Addendum No 001 Narrative

To Drawings and Specifications dated October 5, 2023

Walnut Grove Intermediate School – Science Classroom Modernization **West Covina Unified School District**

PBK Project No.: 202117
DSA A#: A# 03-123048
DSA File No.: 19-110

17 BASE SINK CABINET STATION 1" = 1'-0"

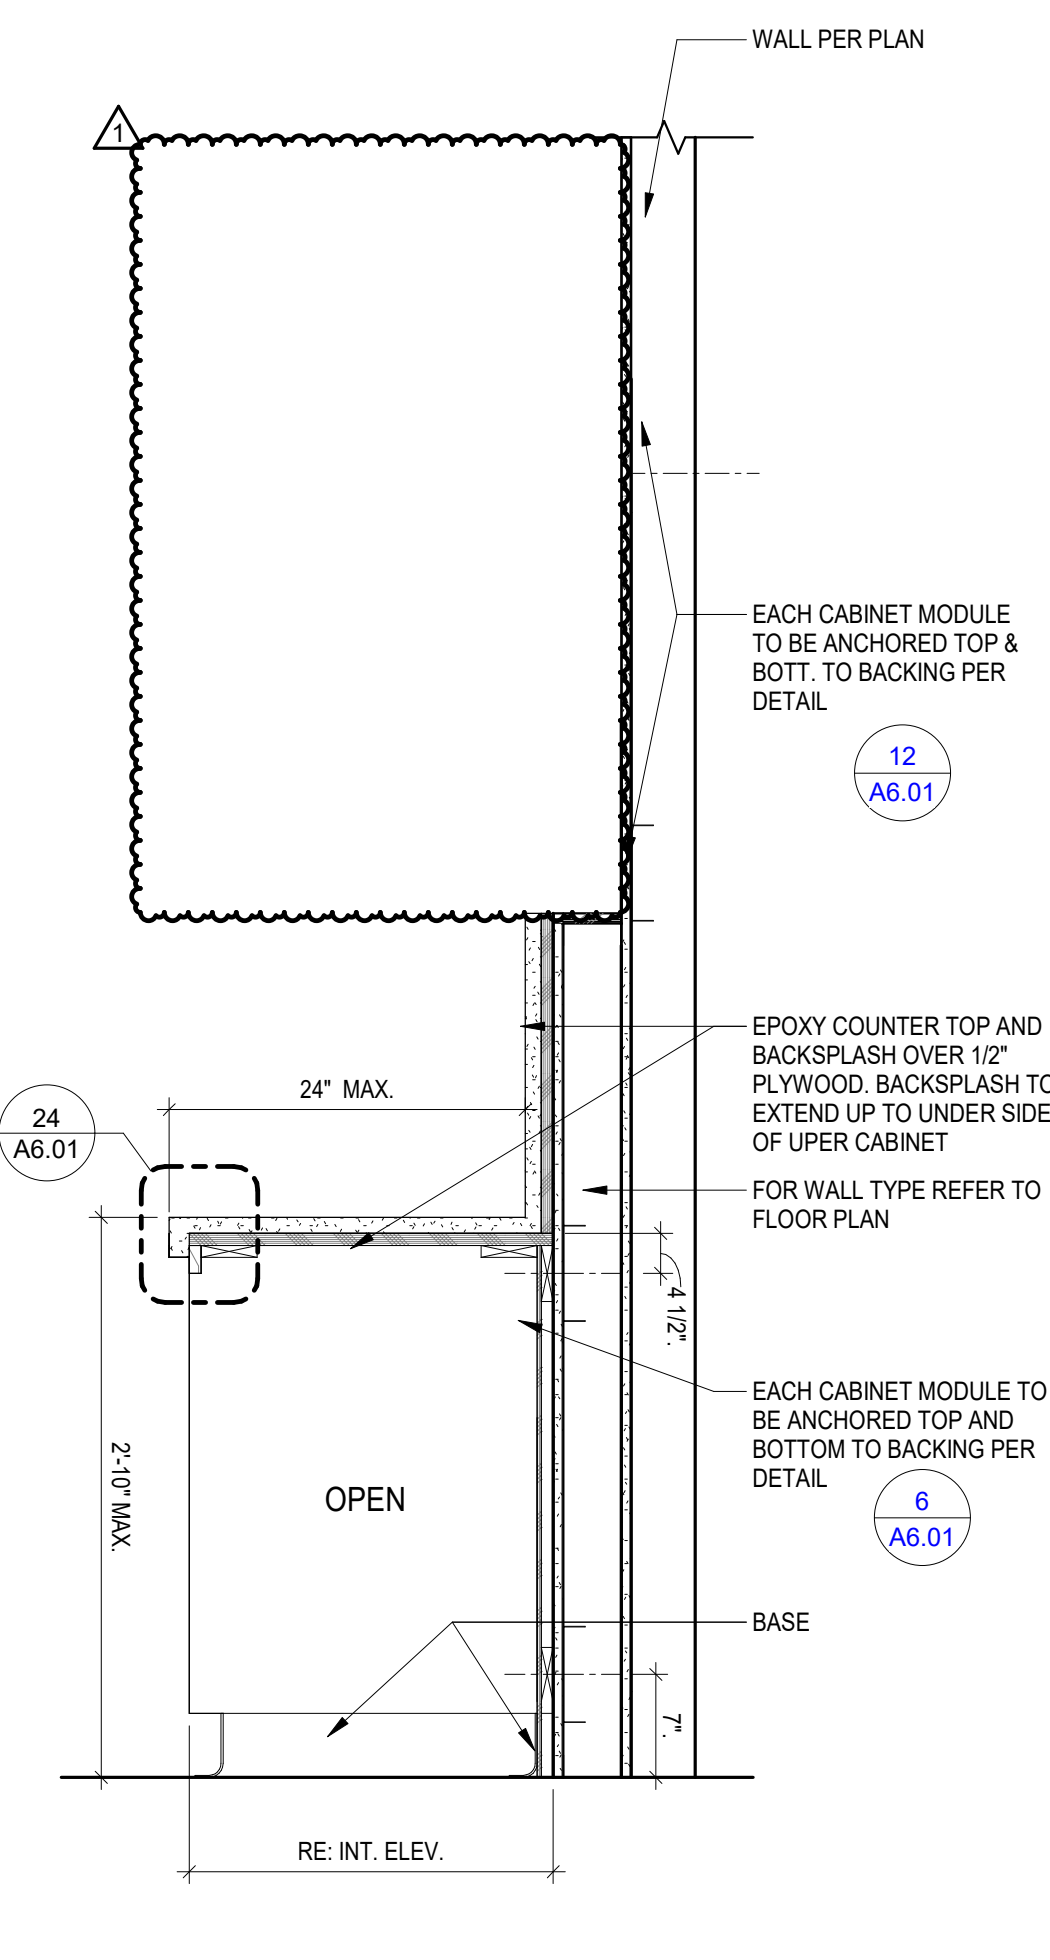
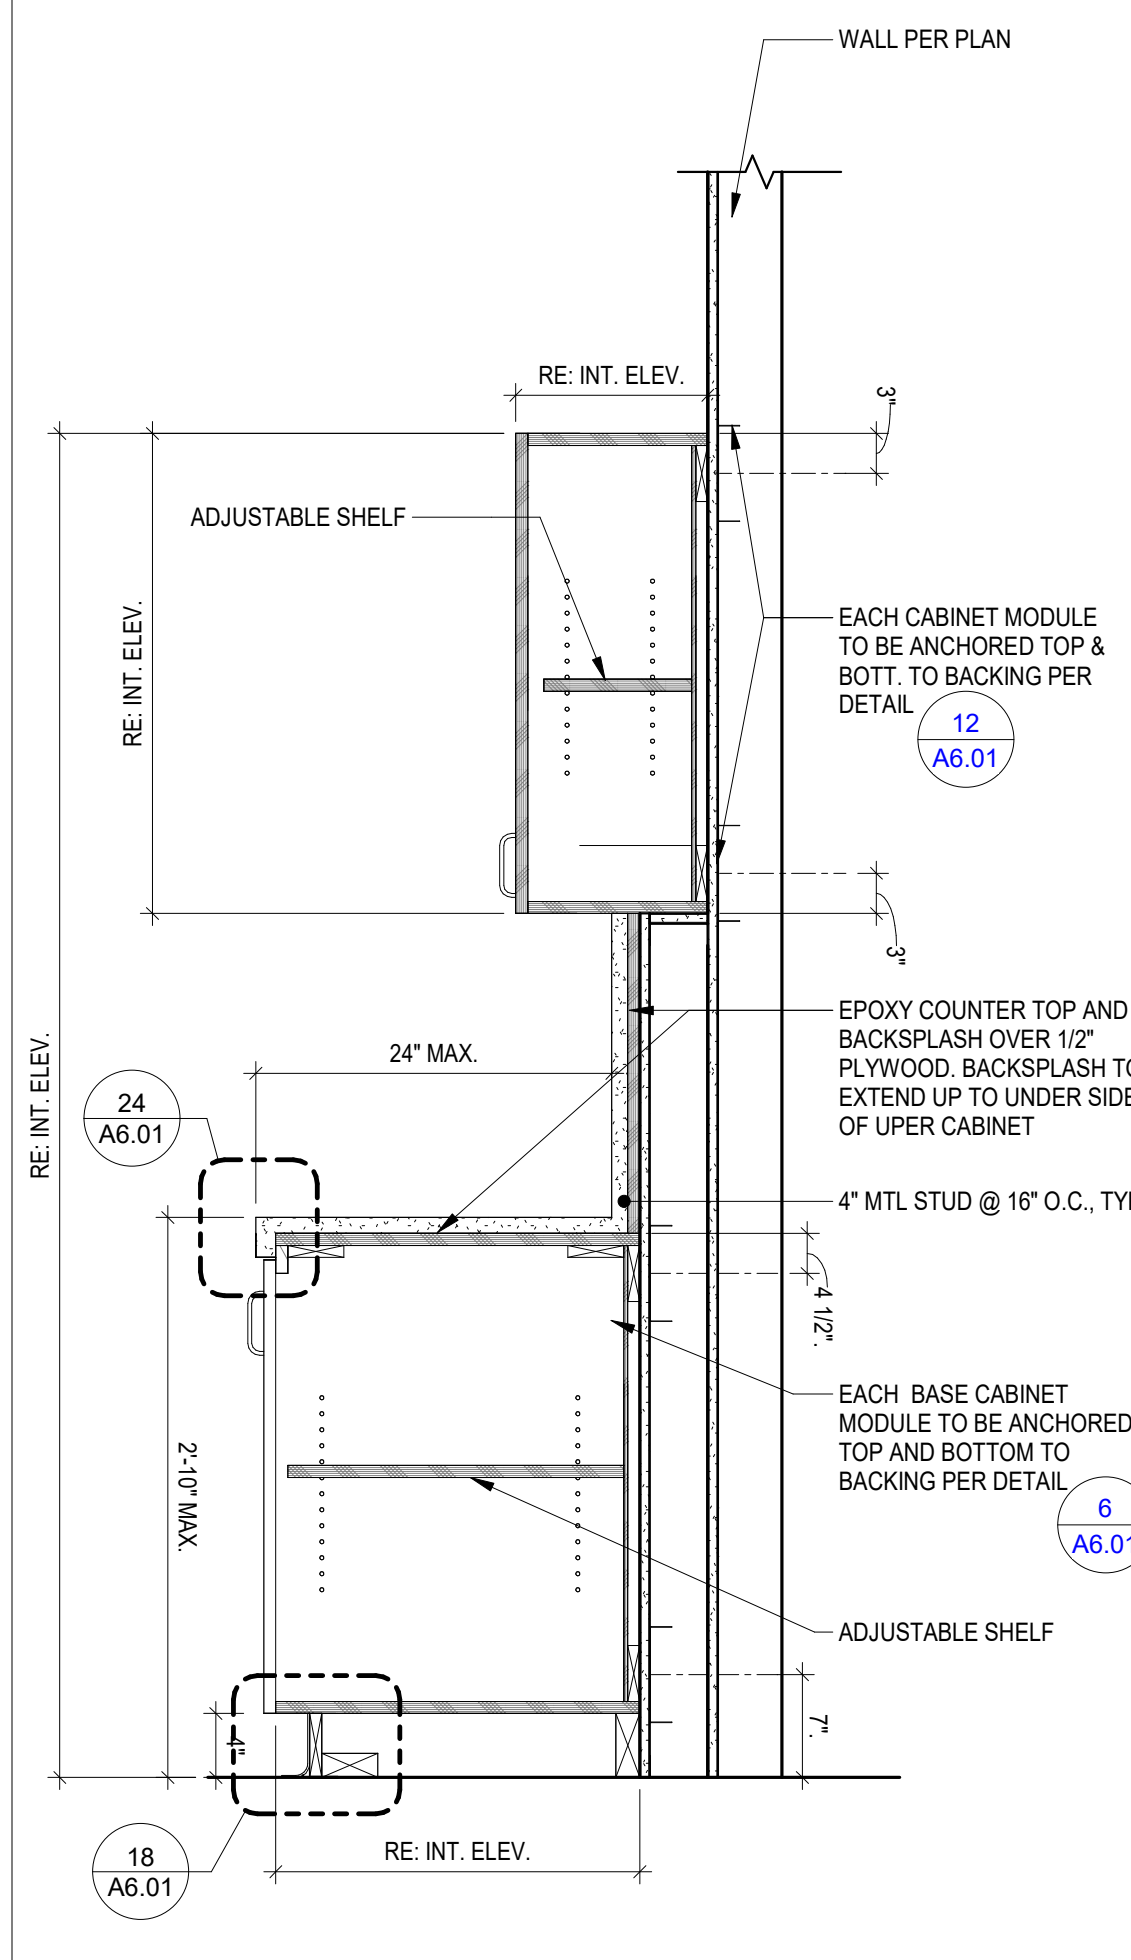
- A) Edited details 16 and 17 by removing the upper cabinets from the details.
- B) Added bubble callout view references (14/A6.01, 15/A6.01, 16/A6.01, and 17/A5.01) to viewport 5.
